PROPOSED CHANGE NO. SC-01-002R1

Date: July 24, 2025
File: 9.1.7.4.2_SC-01_PC
Project No.: 2215C
Project: TA Blakelock HS Reno - Phase 3
Subcontract: SC-01 General

Description: Elevator 2 (drama area)

CONTEMPLATED CHANGE NOTICE No. S1

2 SECTION - ELEVATOR AT CAFETERIA
A104 1:50

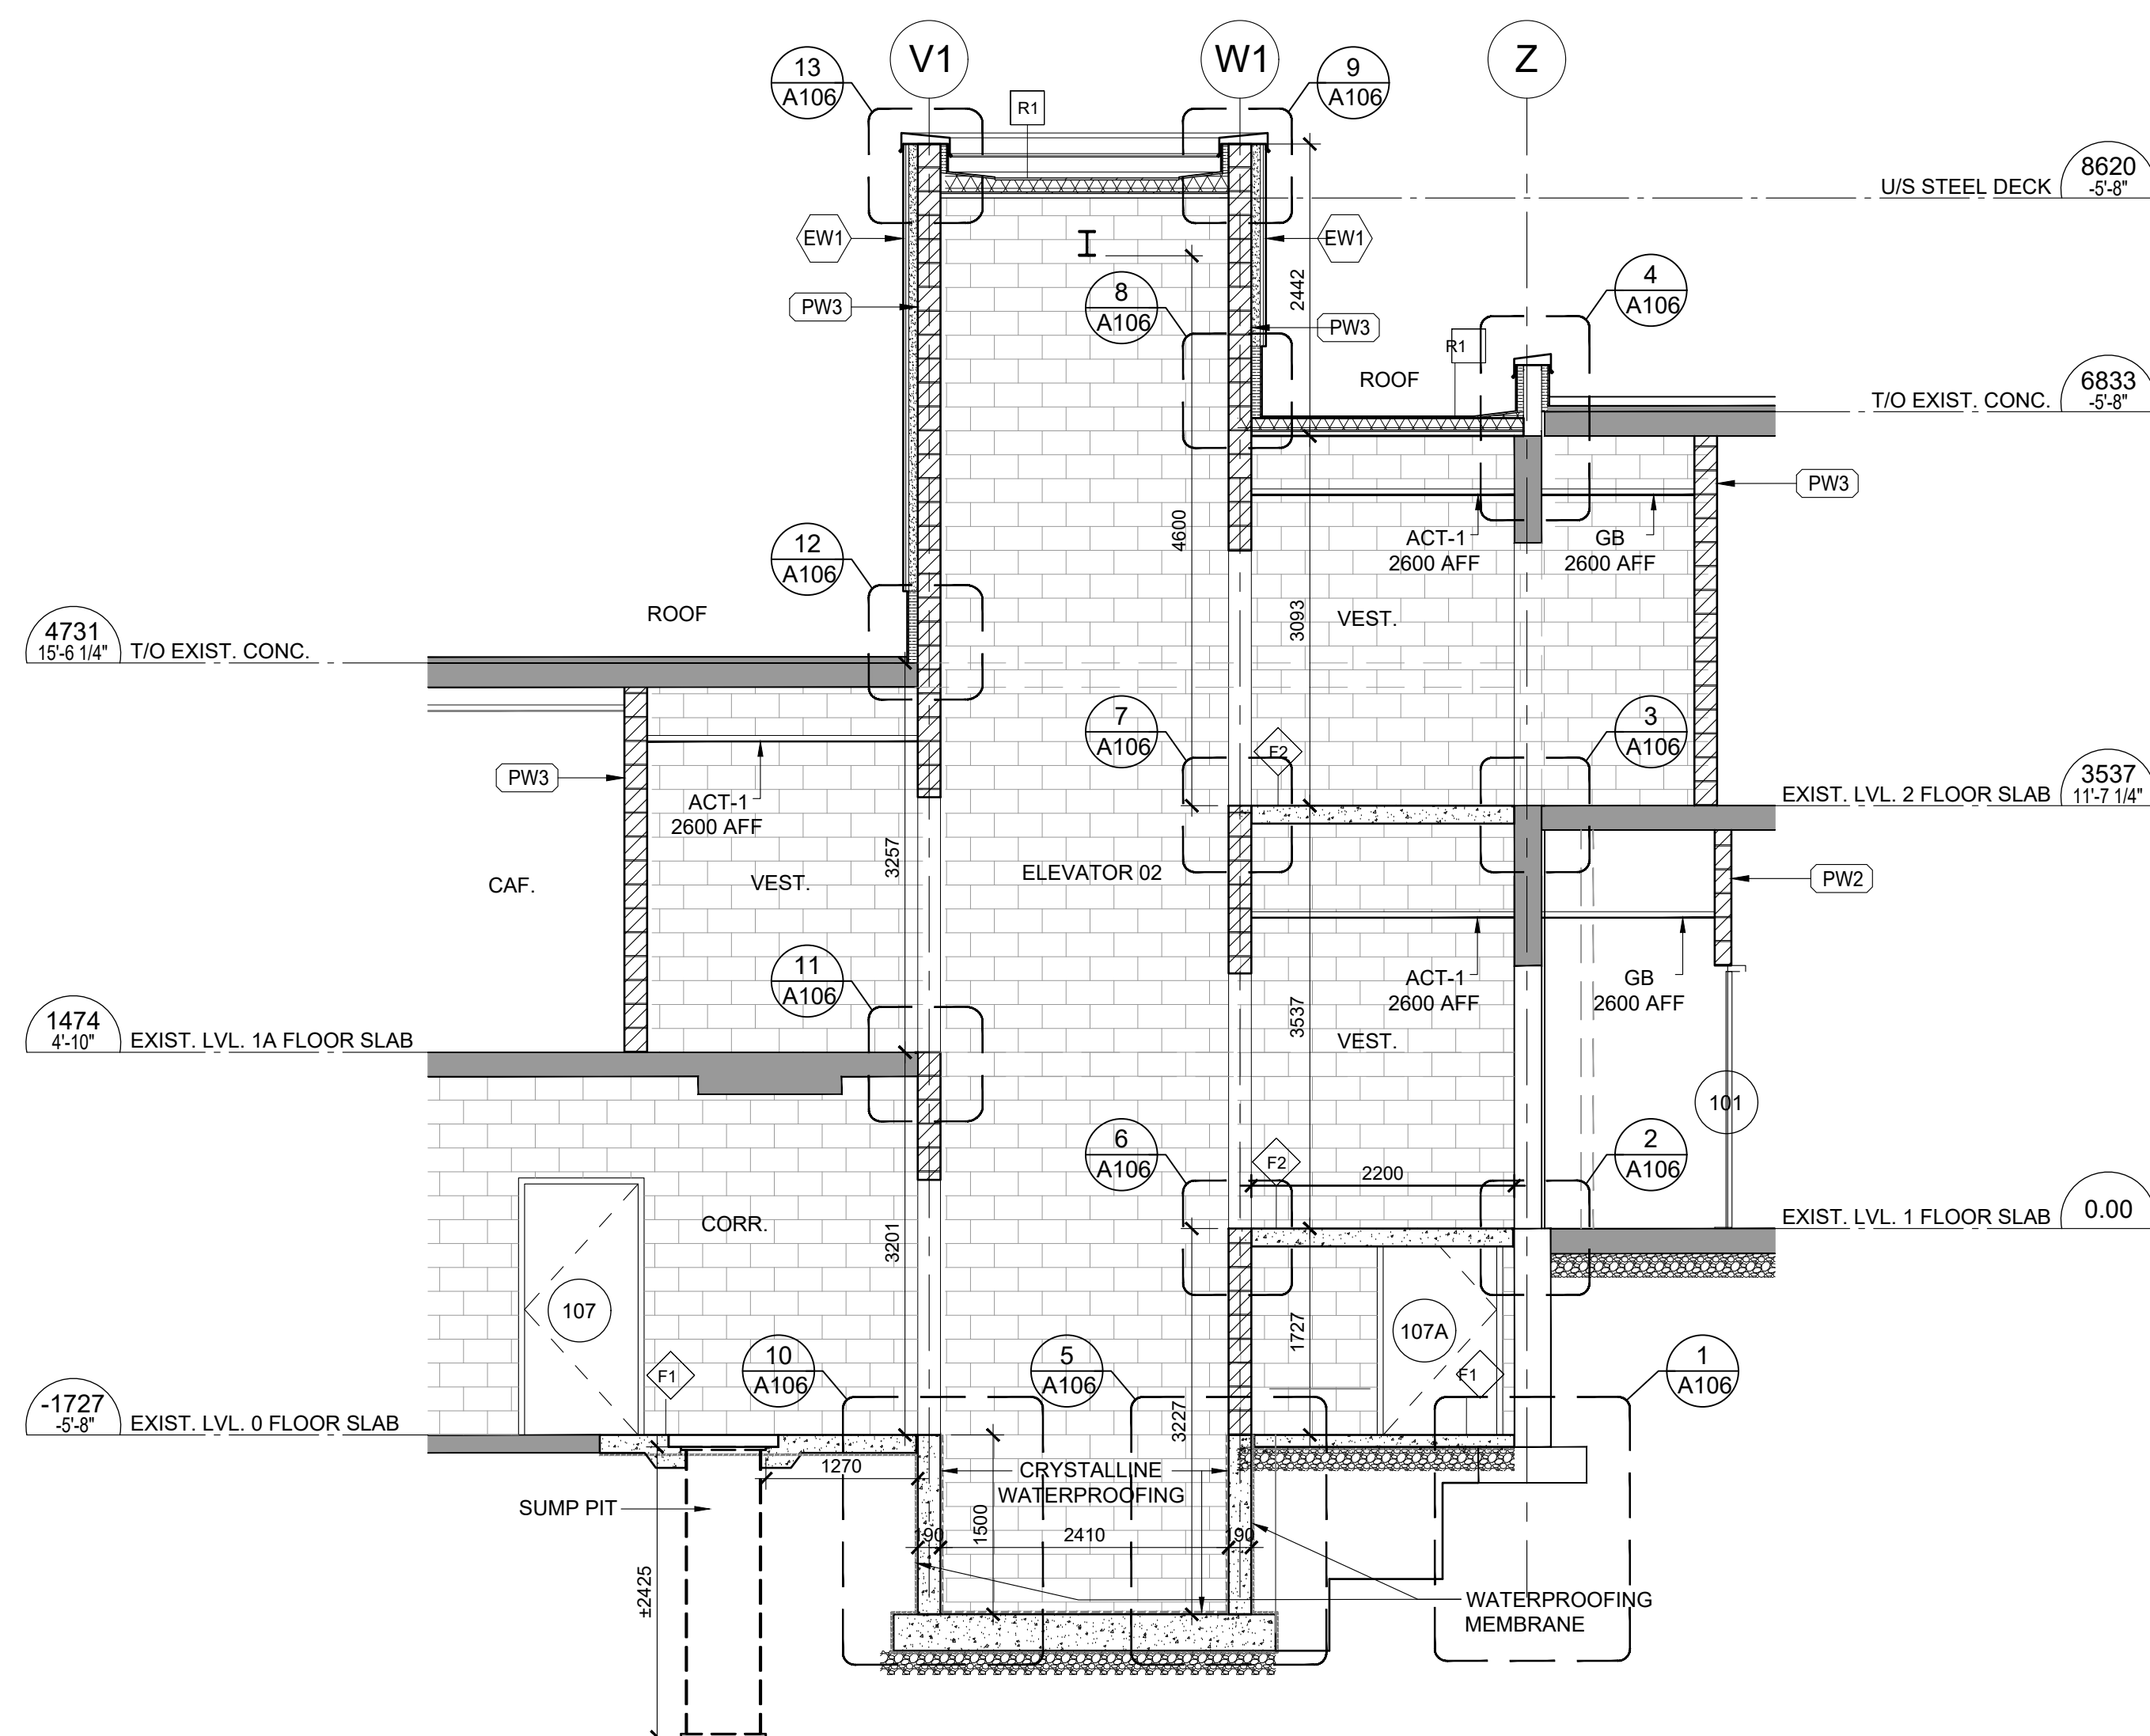
1. Refer to attached updated A100 floor plans and A104 updated sections.
2. Refer to Structural CONTEMPLATED CHANGE NOTICE No. S1 item 1 for requirements.
3. Mechanical CCN to follow adjusting sump pit location and corresponding drainage and piping to it. Electrical CCN to follow confirm power and control until location for sump pit.
4. Refer namely to sump pit relocation, deletion of underpinning along West side of Drama Room (Refer to Structural CCN for scope).
5. Provide 36x 36 ACUDOR FT-8050 concrete floor door, single leaf, 1" recessed to receive flooring. Provide cut sheet. Note this ACUDOR is intended to clear the 24" dia sump pit including sump pit flange. Confirm with vendor. Set sump pit lid just at u/s of lid opening. Provide cut sheet of ACUDOR. Run sump pit venting and discharge line within adjacent 190mm CMU wall.

Drawing Title:
**EAST ELEVATOR
DETAILS**

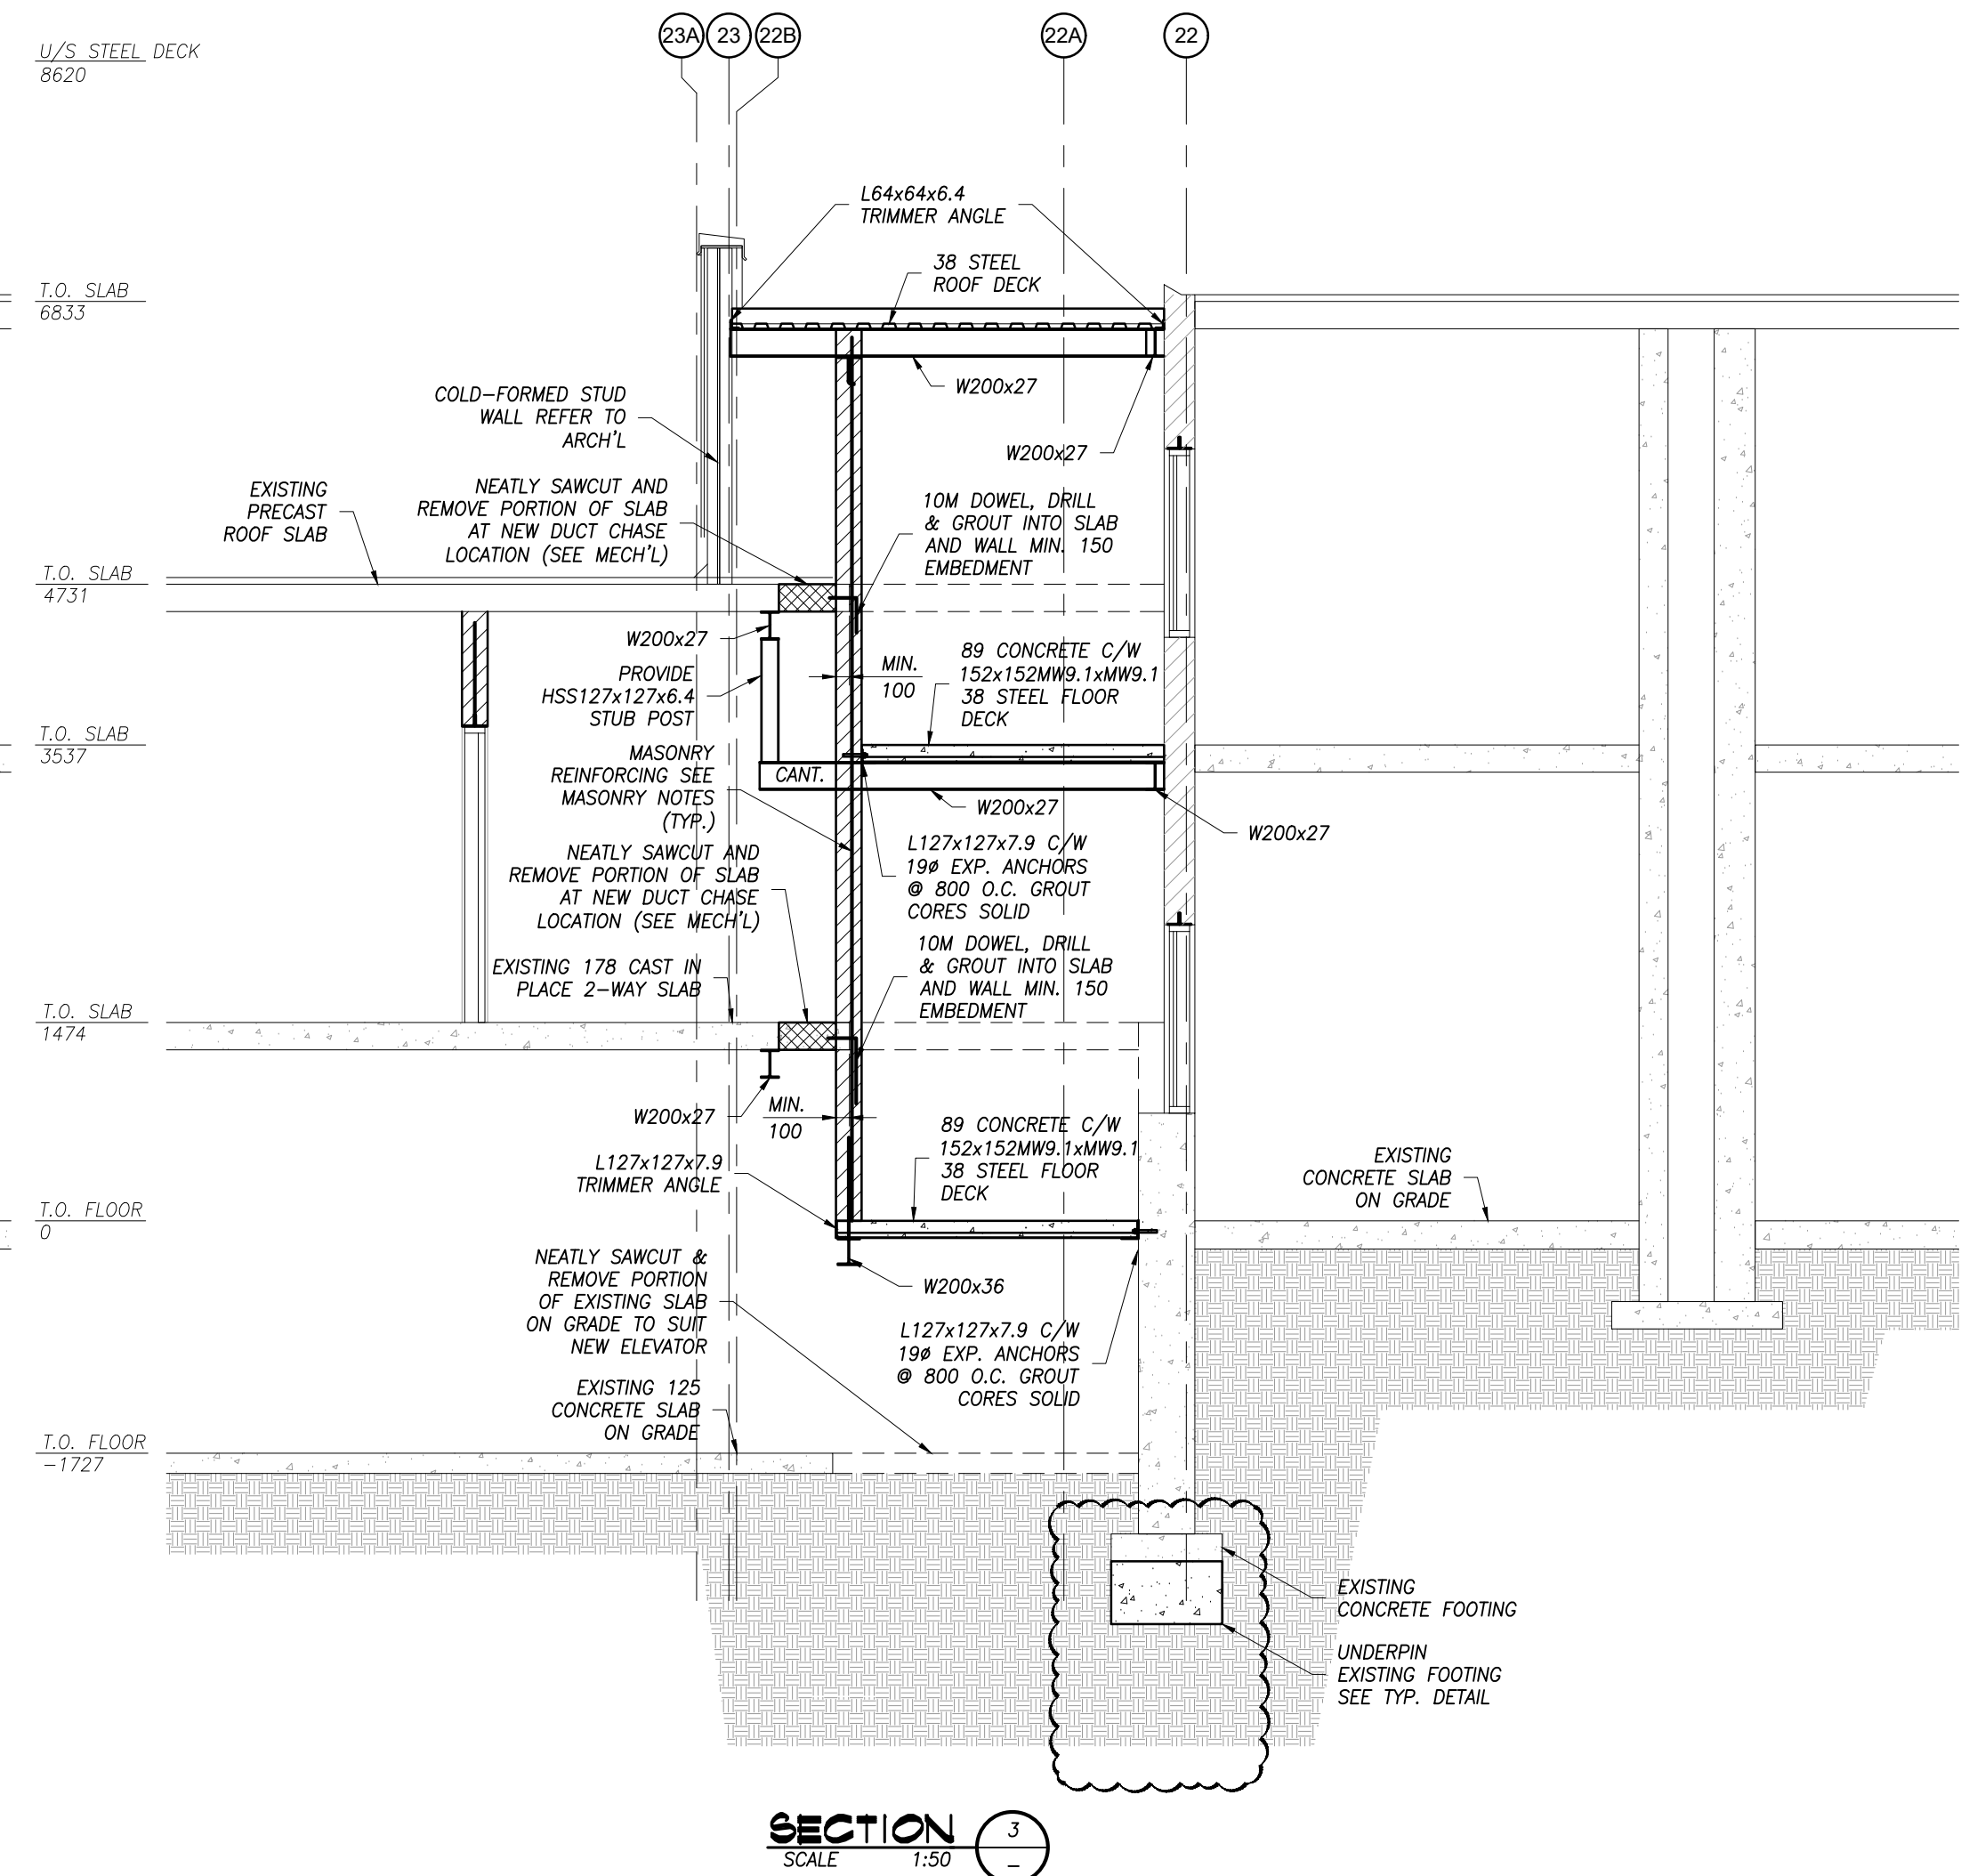
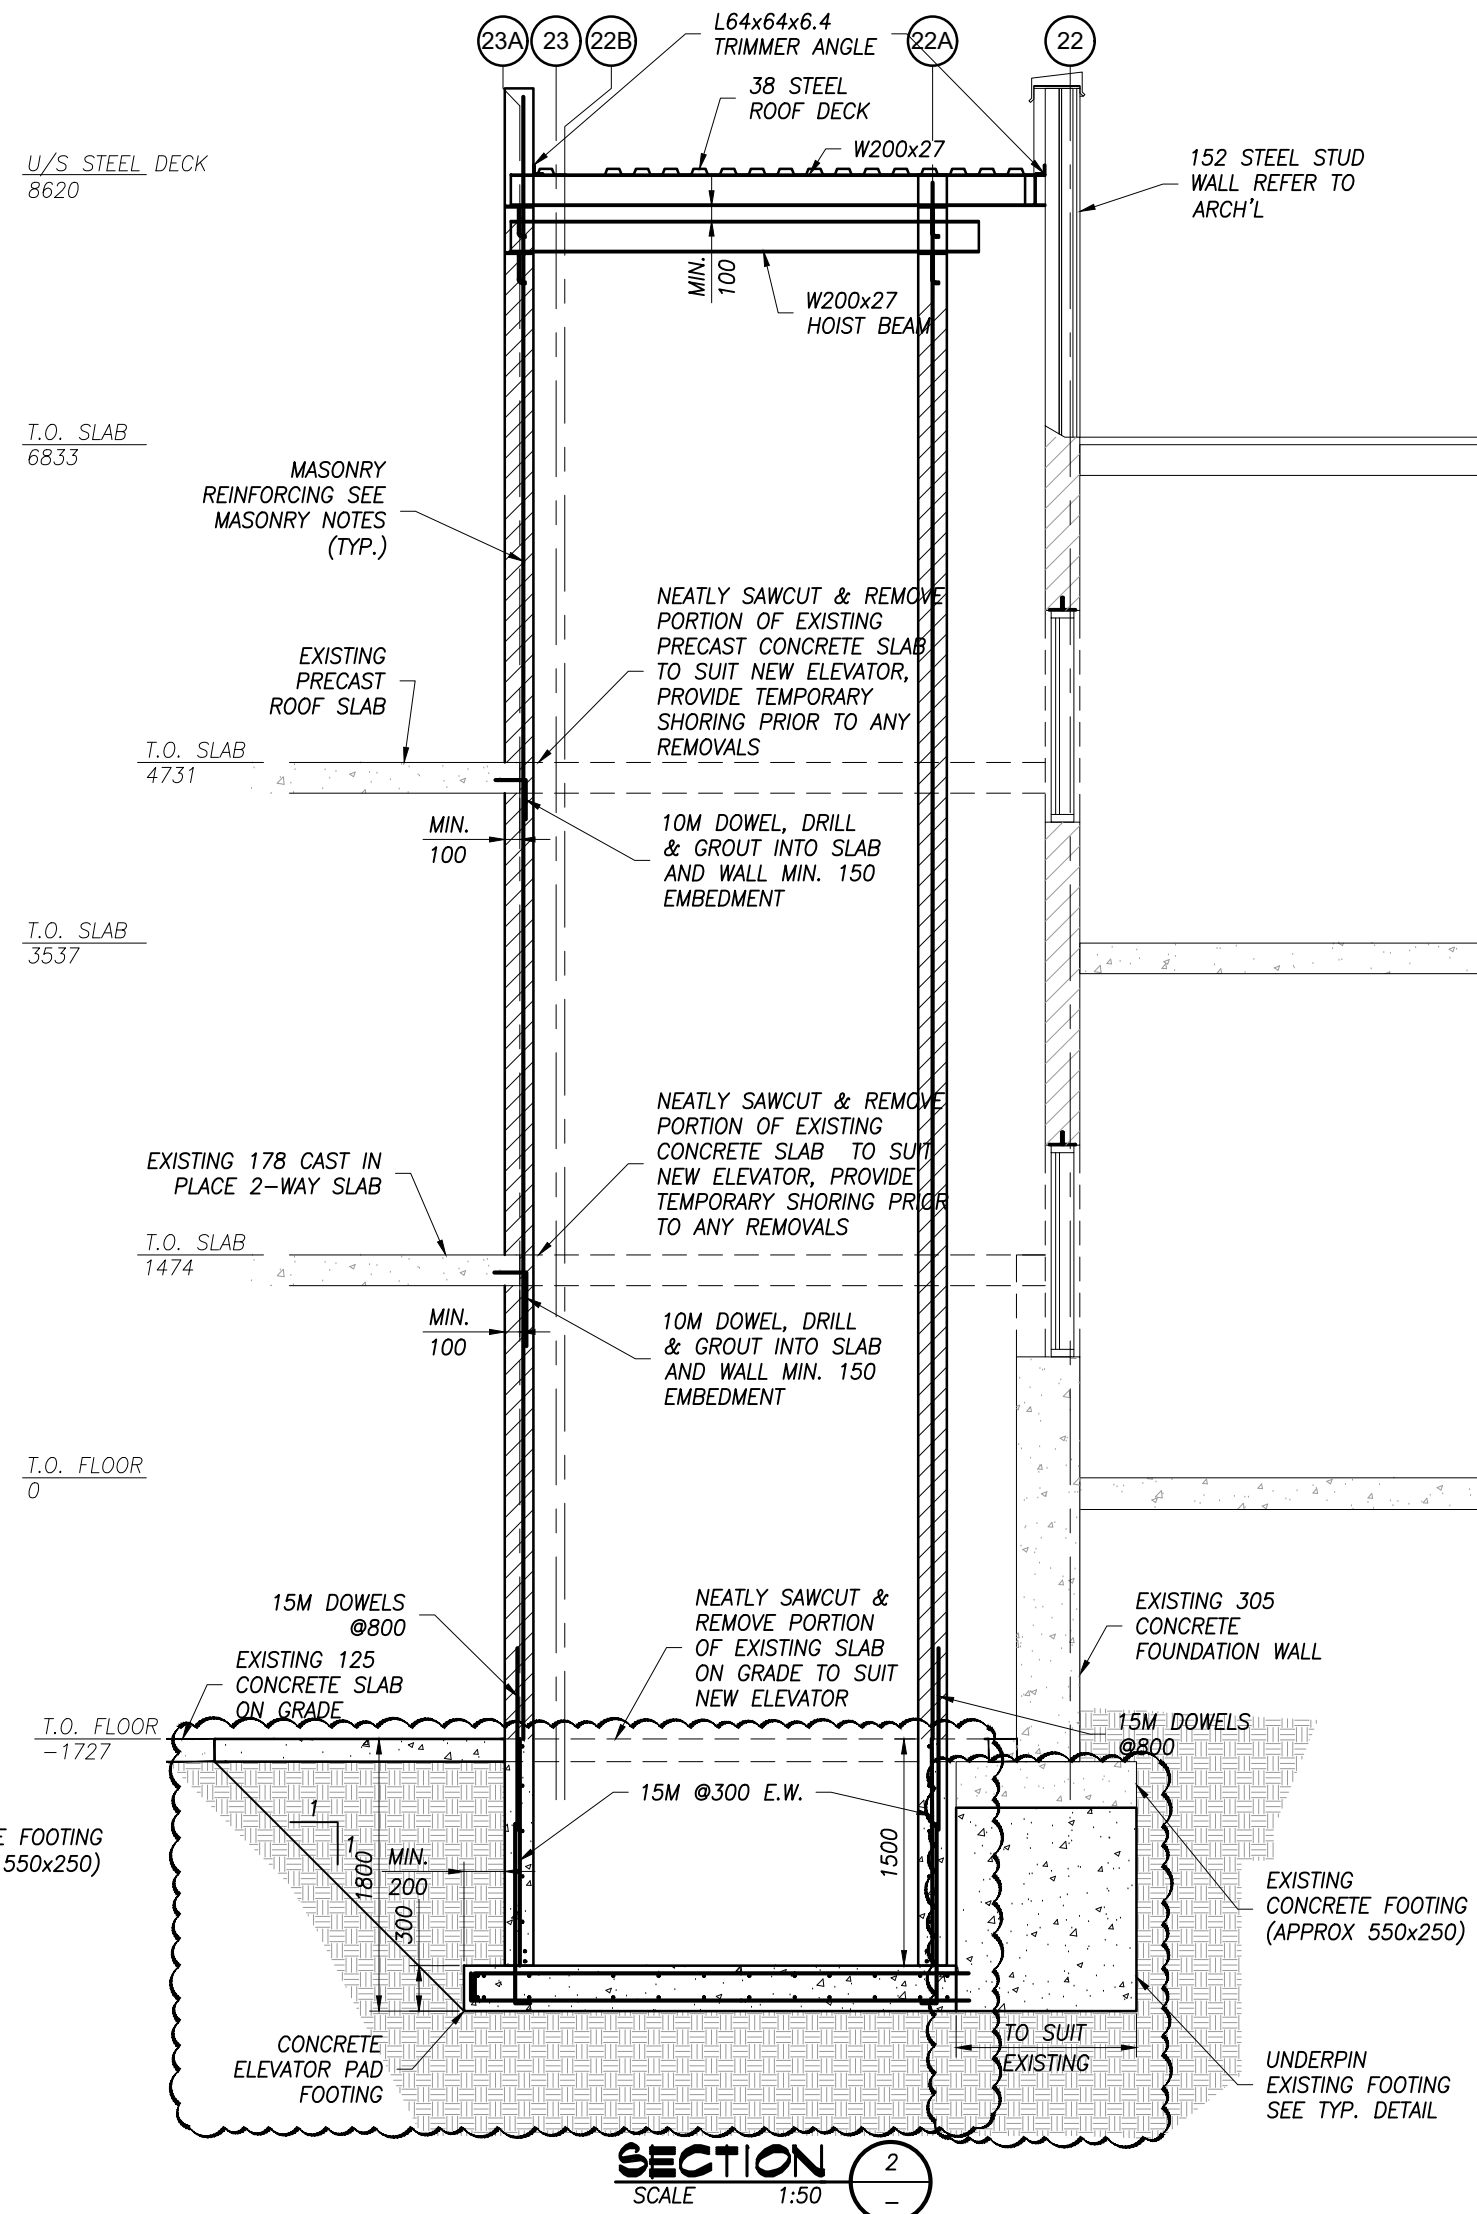
1. Underpinning extents and depths for Elevator 2 revised. Refer to updated drawing S300.
2. Foundation support for new column in Washroom Renovation revised. Refer to updated drawing S100.
